# SANDY CITY COMMUNITY DEVELOPMENT

## Staff Report Memorandum May 15, 2025

To: Planning Commission  
From: Community Development Department  
Subject: Sandy Station Block 20 Subdivision  
(HSD Architectural Review)  
240 East 8960 South  
[Community #4, Historic Sandy]

SUB09282022-006410  
R-1-7.5(HS)  
.23 Acres  
2 Lots

## New Garage, 240 E 8960 S

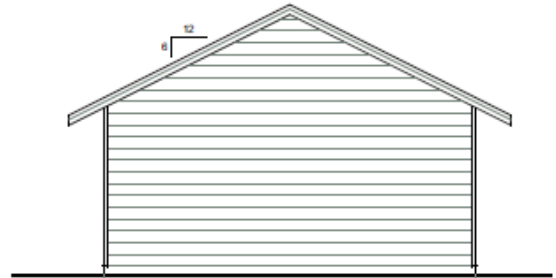
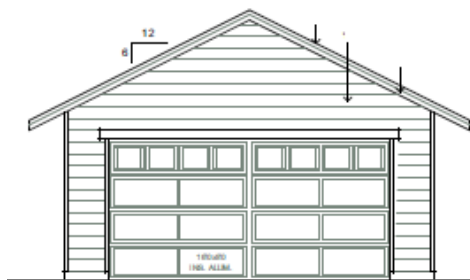
The adjustment of the property line between lots will require the existing two-car garage that serves the north property be demolished. A replacement two-car garage must be provided for this home to ensure compliance with on-site parking requirements.
